CITY OF NEW BEDFORD, MASS.		SHEET 1 OF 2	
RAIL YARD CSO RELOCATION PROJECT WITH PARKING			
CHANGE ORDER NO 2 - WHALES			
ELECTRICAL PLAN			
STV Incorporated 321 Summer Street Boston, MA 02210		PROJECT MANAGER	
SCALE: 1" = 40'-0"	DRAWN BY: WD	CHECK BY: MC	PLAN NO. SHEET E-2
DATE: 10-03-03	WD	MC	PK

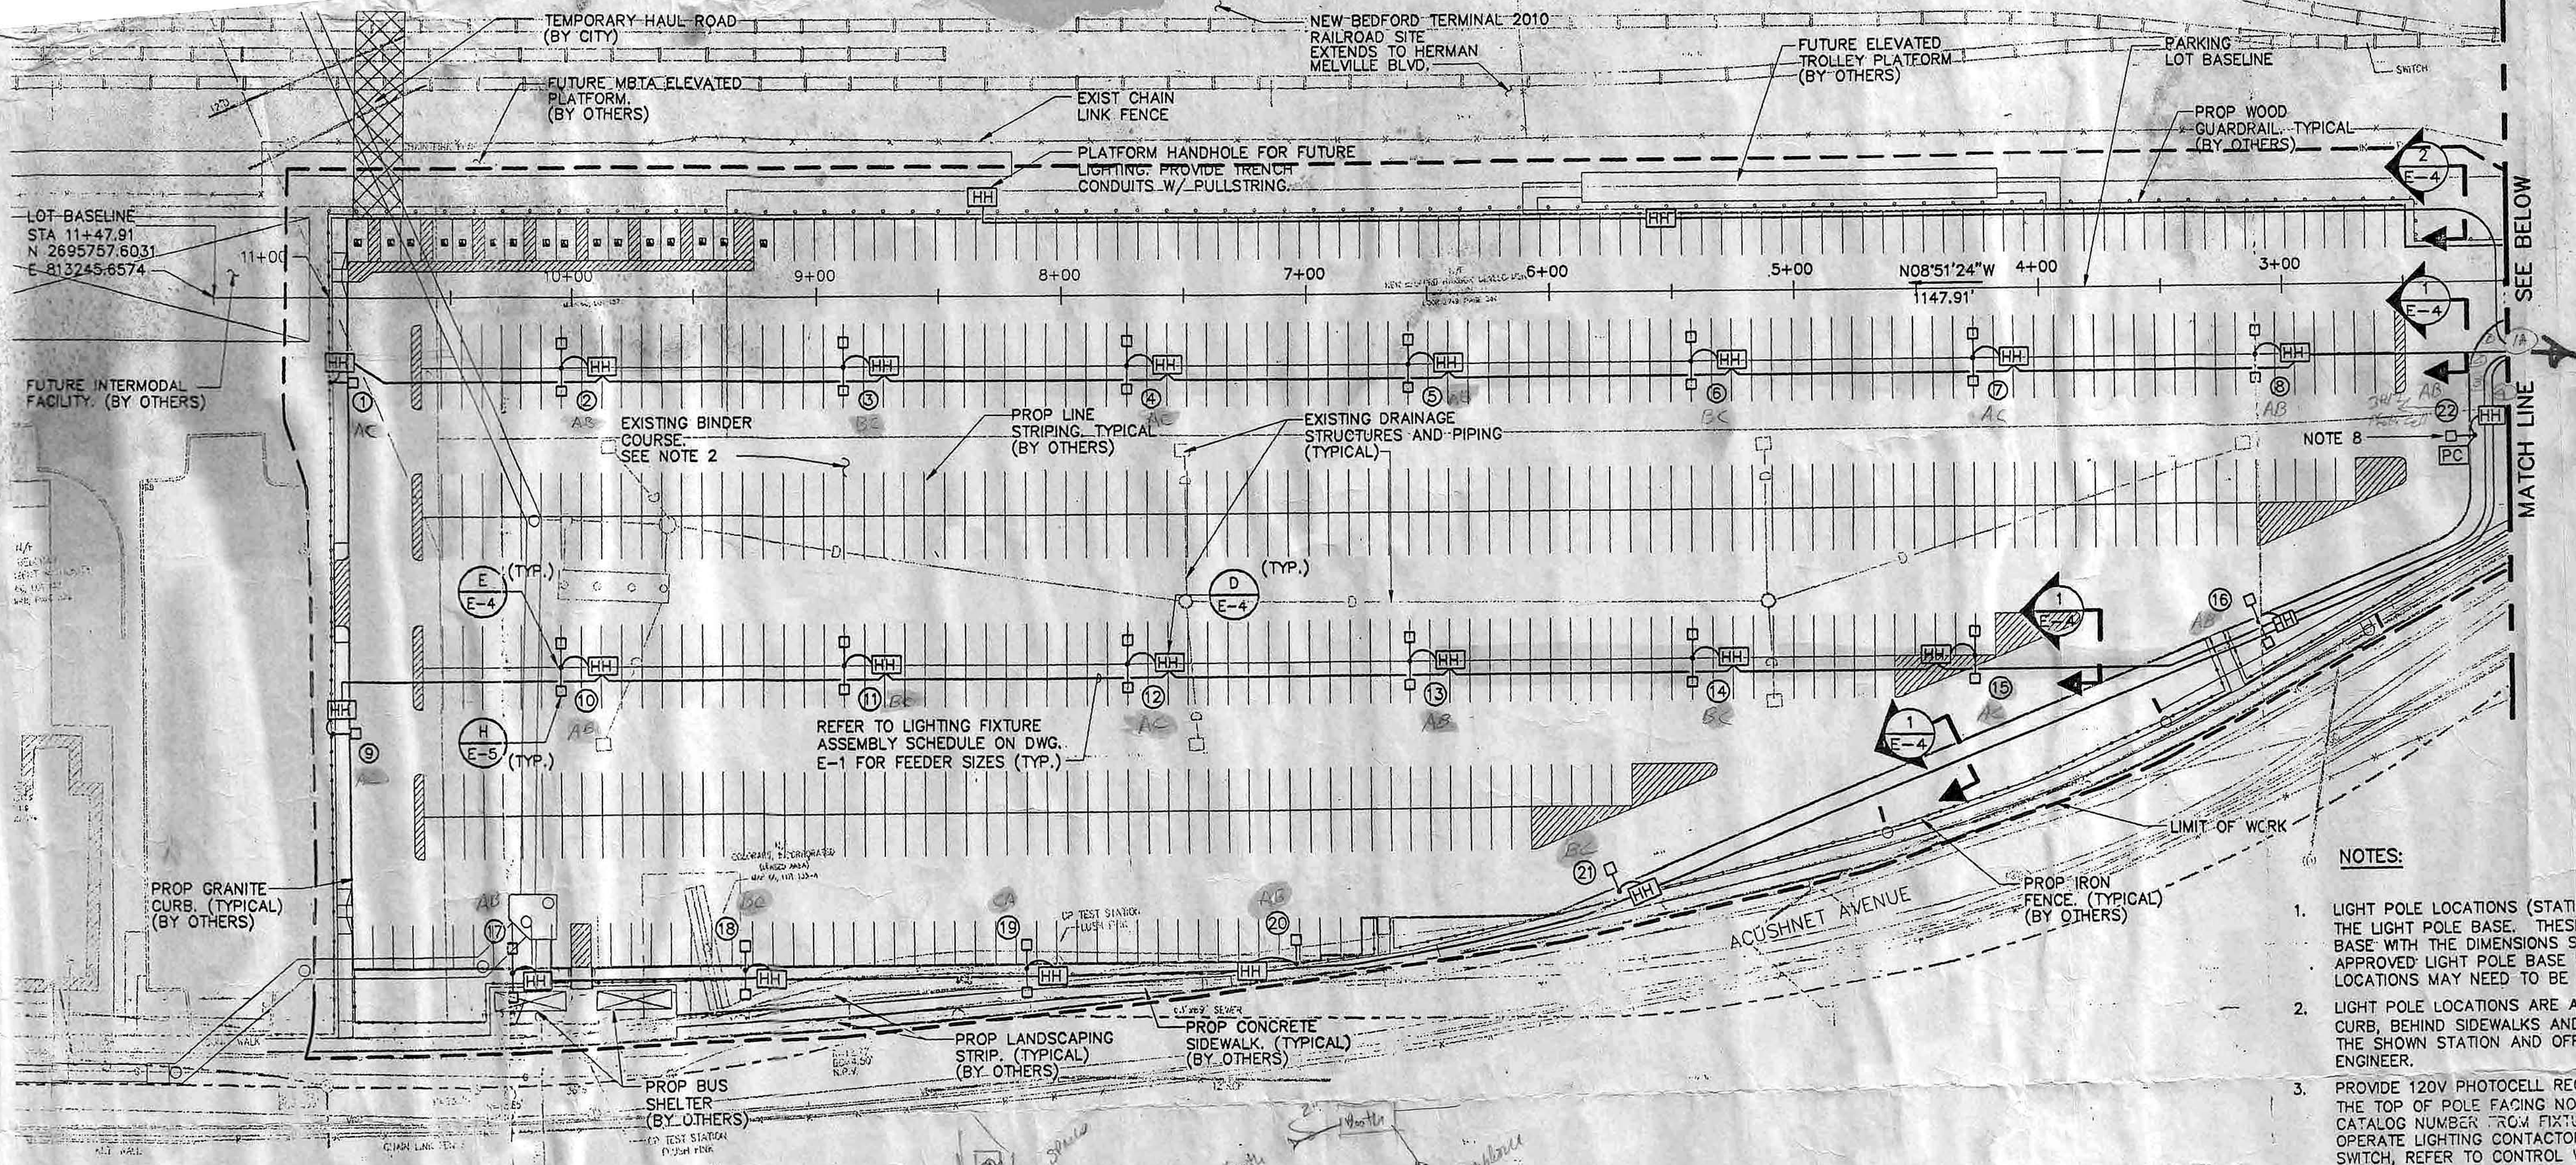
4. ELECTRIC SERVICE CONNECTION REFER TO ONE-LINE DIAGRAM ON DWG. E-3 FOR ADDITIONAL INFORMATION.
5. TELEPHONE SERVICE CONNECTION. 2" CONDUIT AND 2" SPARE CONDUIT FROM EXISTING VERIZON UNDERGROUND CONDUIT AND NEW VERIZON INSTALLED HANDHOLE TO FARE COLLECTION BOOTH BACKBOARD. ALL WORK SHALL BE COORDINATED WITH VERIZON.

ISSUE DATE	DESCRIPTION	BY	CHKD	APP
	SPARE TELEPHONE CONDUIT ADDED	CM	MC	PK
